ADDENDUM

Project: Wayne State College
Berry Residence Hall – West
Wing Fire Sprinkler Install

Addendum No.: 2

CHANGES TO CONSTRUCTION DOCUMENTS

Sheet M100 Ground Floor Plan

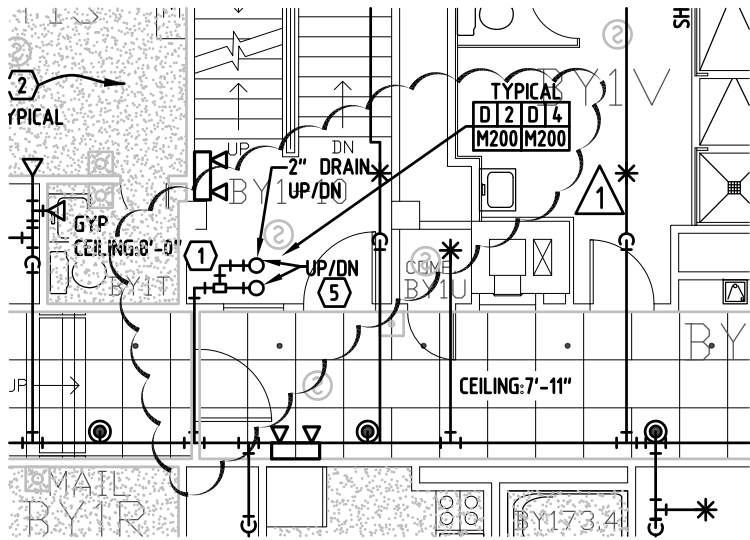
1. Relocate fire sprinkler vertical riser and drain riser to north east corner of the East stairwell in the west wing. See attached plan.
2. Extend drain piping into trash collection room and to the exterior. See attached plan.

3. Add note 13. Note shall read "remove existing ceiling in closet area, install new lay-in ceiling shall utilize model USG 2220 ceiling tiles. Provide sprinkler head in closet. Provide new light fixture to utilize existing circuit. Light shall be Lithonia lighting model WF6 6" LED module." Note shall point to (2) closets per floor in the west wing, one adjacent to the east restroom, one adjacent to the west restroom.

4. Add note 14. Note shall read "Remove and replace emergency fixture with new Lithonia model #elm-41 or approved equal for (10) locations in the EAST wing, this is in addition to the (16) total fixtures for the west wing." Note shall point to the east side corridor.

Sheet M101 First, Second, Third Floor Plan

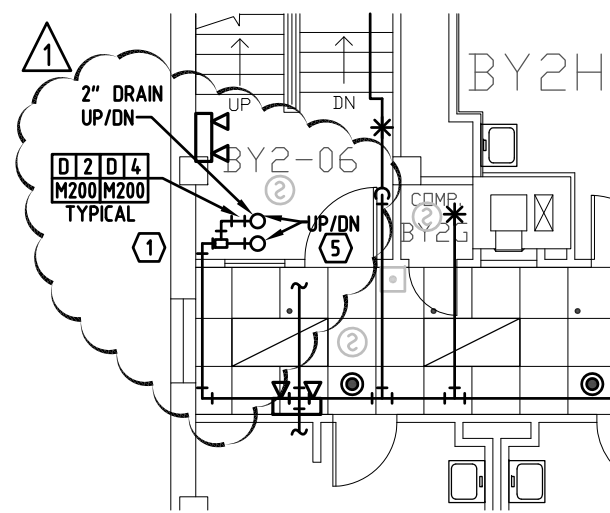
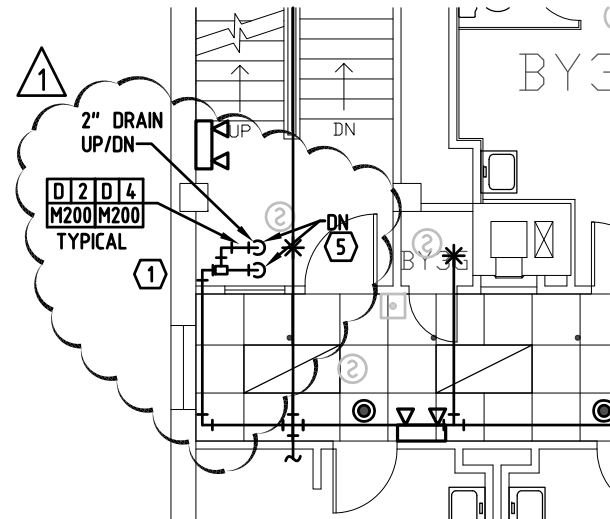
5. Relocate fire sprinkler vertical riser and drain riser to north east corner of the East stairwell in the west wing. See attached plan.
6. Note 2 in the corridor on the second floor should read note 3.
7. Add note 10. Note shall read "remove existing ceiling in closet area, install new lay-in ceiling shall utilize model USG 2220 ceiling tiles. Provide sprinkler head in closet. Provide new light fixture to utilize existing circuit. Light shall be Lithonia lighting model WF6 6" LED module." Note shall point to (2) closets per floor in the west wing, one adjacent to the east restroom, one adjacent to the west restroom.
